**BOARD OF APPEALS, CITY & COUNTY OF SAN FRANCISCO**

Appeal of  
JASON FILIPPI and GABOR TURSCHL, \_\_\_\_\_ )  
Appellant(s) )  
vs. )  
DEPARTMENT OF BUILDING INSPECTION, \_\_\_\_\_ )  
Respondent

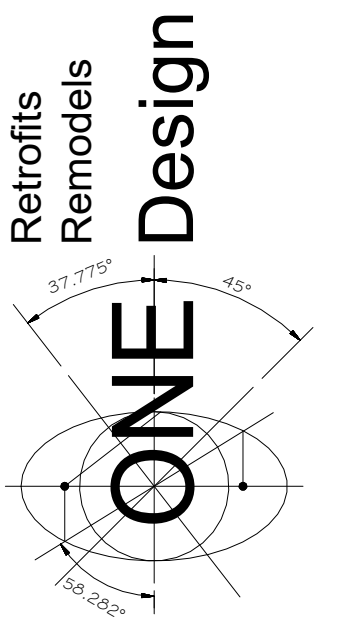
Comment: \_\_\_\_\_  
\_\_\_\_\_  
\_\_\_\_\_

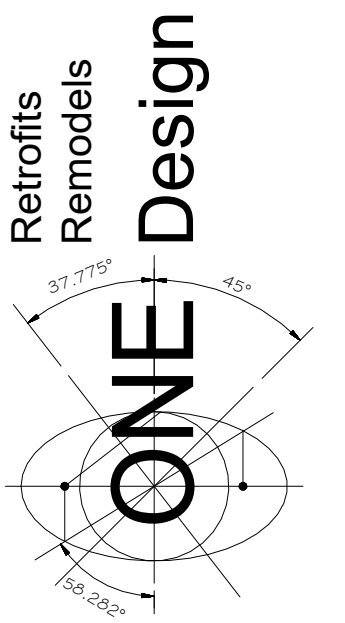
Comment: \_\_\_\_\_  
\_\_\_\_\_  
\_\_\_\_\_

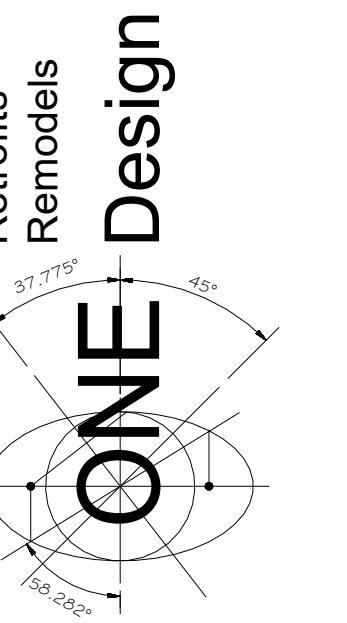
Comment: \_\_\_\_\_  
\_\_\_\_\_  
\_\_\_\_\_

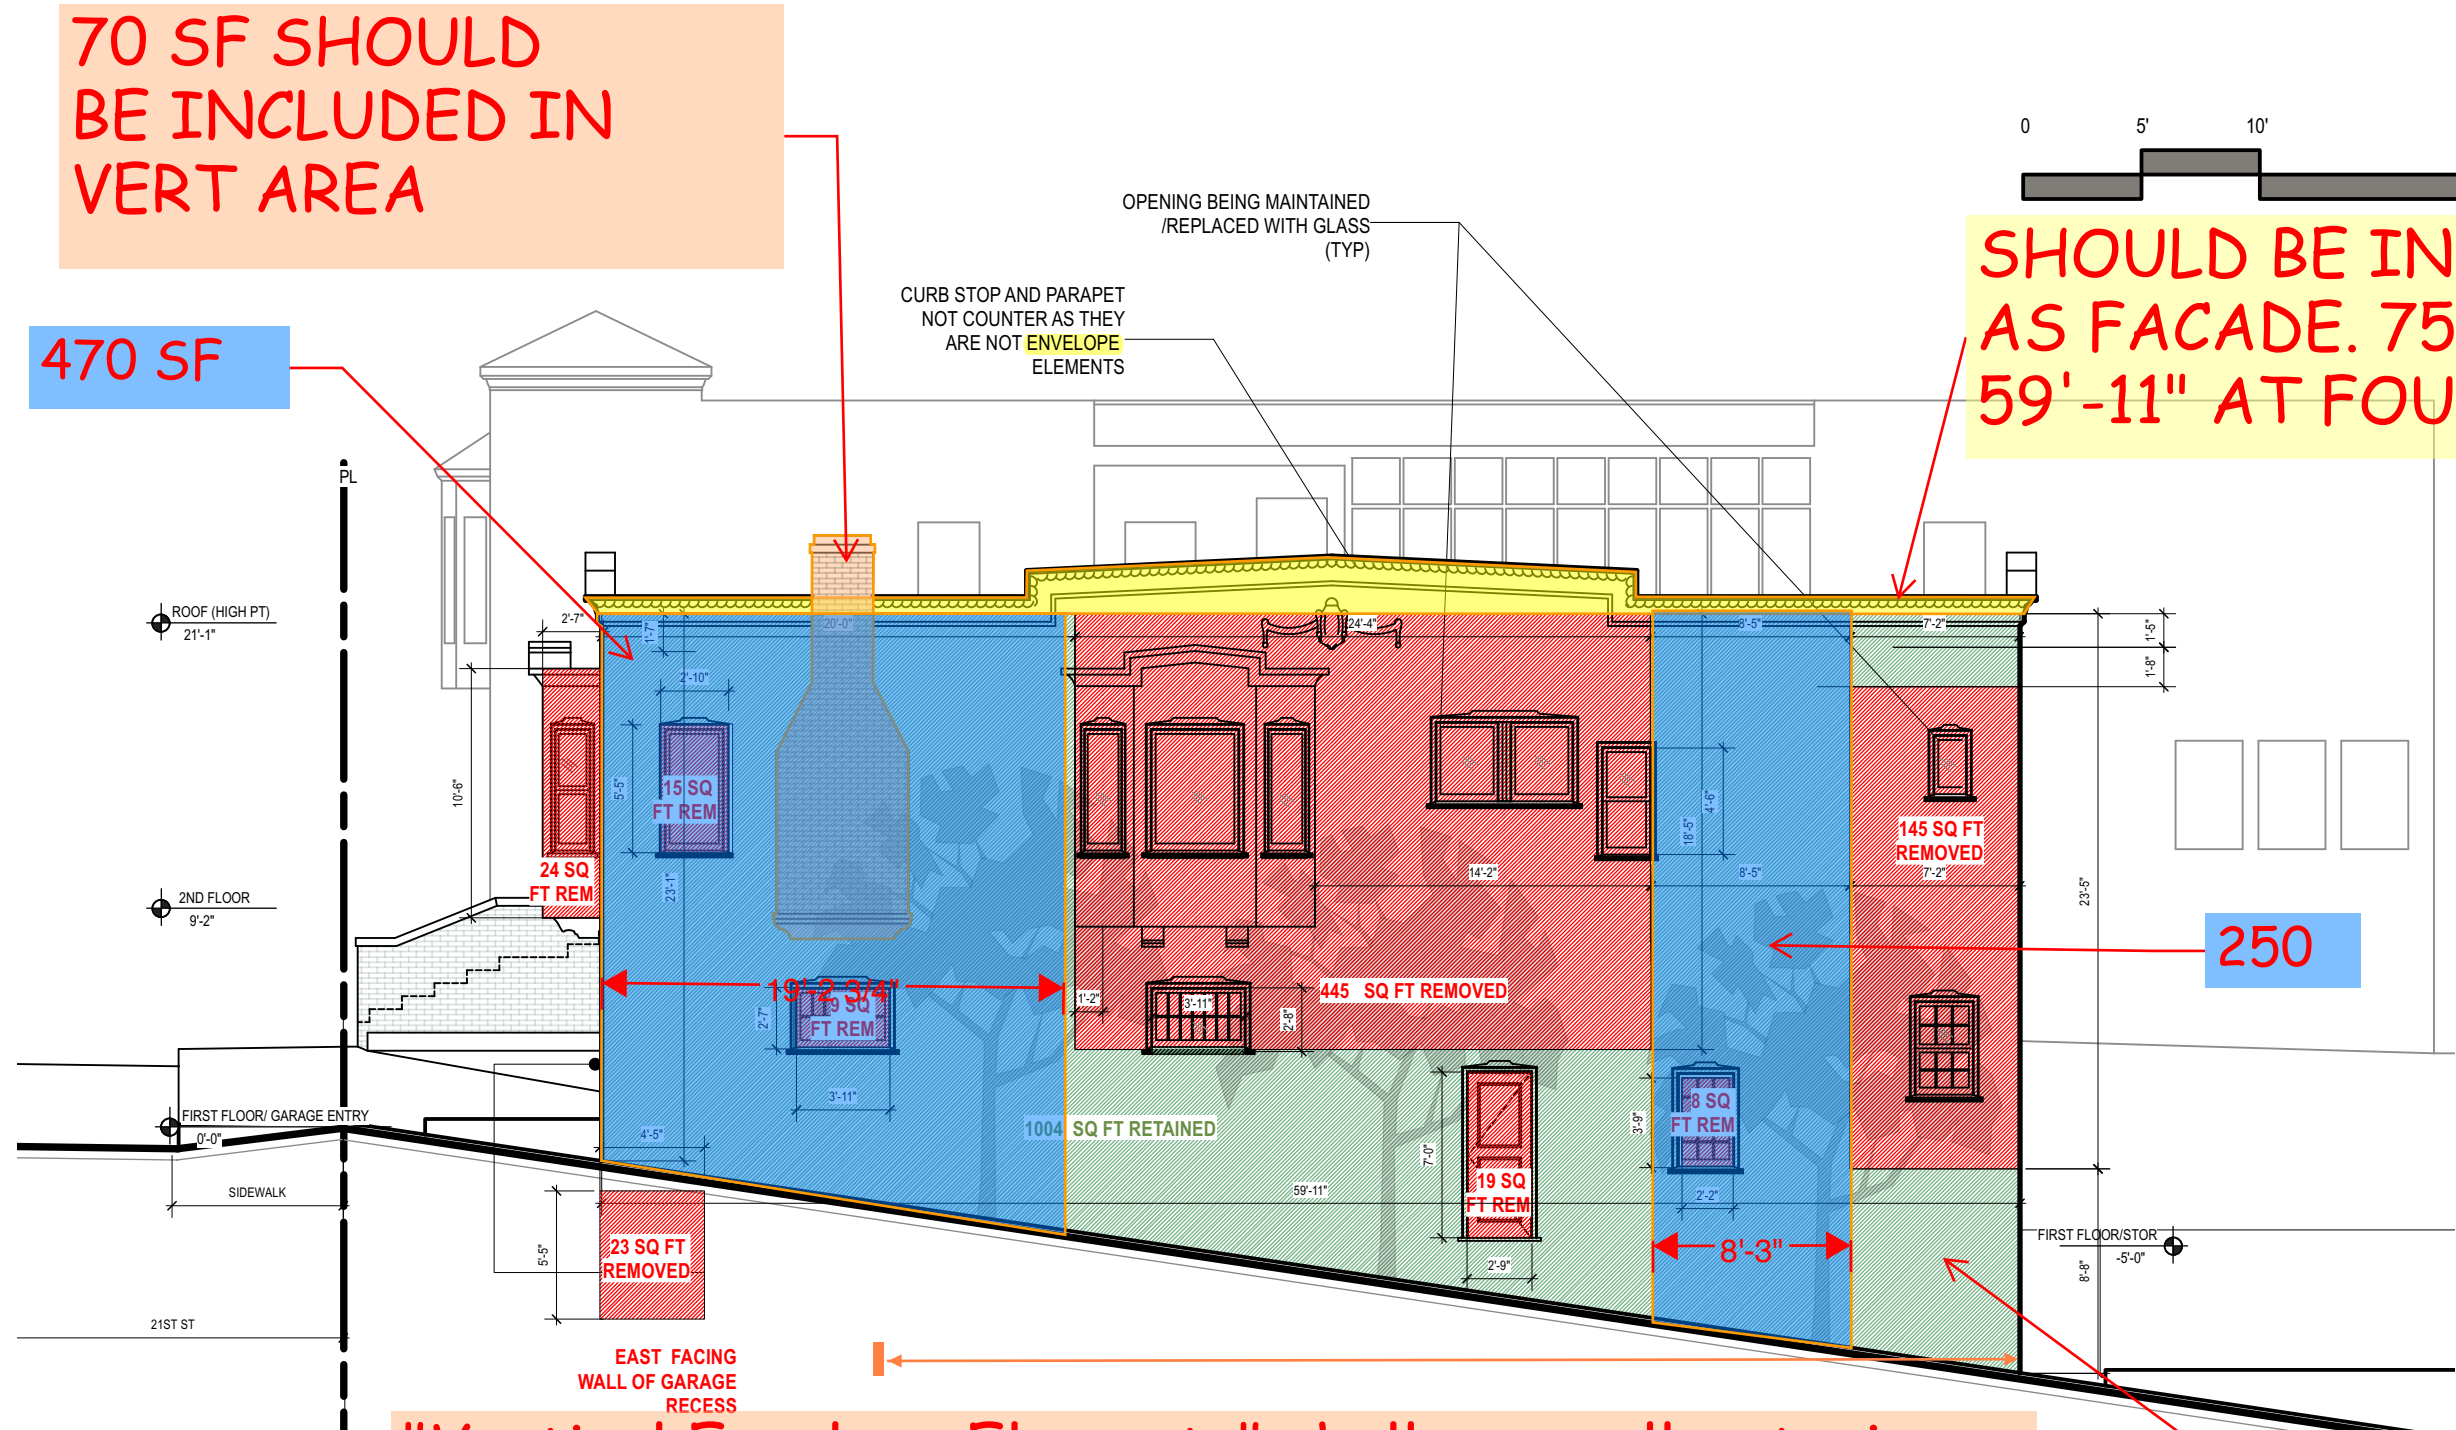
1 Per Section 317(b)(5), horizontal elements shall mean all roof areas and all floor plates, except floor plates at or below grade. Changing the level of an existing floor plate is considered "removal."  
Removal of floor plates to accommodate a new stair is considered "removal."  
2 Changing the level of an existing floor plate is considered "removal." Removal of floor plates to accommodate a new stair is considered "removal."  
3 To use Section 317(b)(2)(B)(i) clause of "removed and replaced for repair or maintenance," Owner must provide documentation such as: 1) (During Design Review) an engineer's report to show existing is beyond repair and requires replacement, or 2) (During Construction) a "Correction Notice" issued by DBI to show requirement to repair.
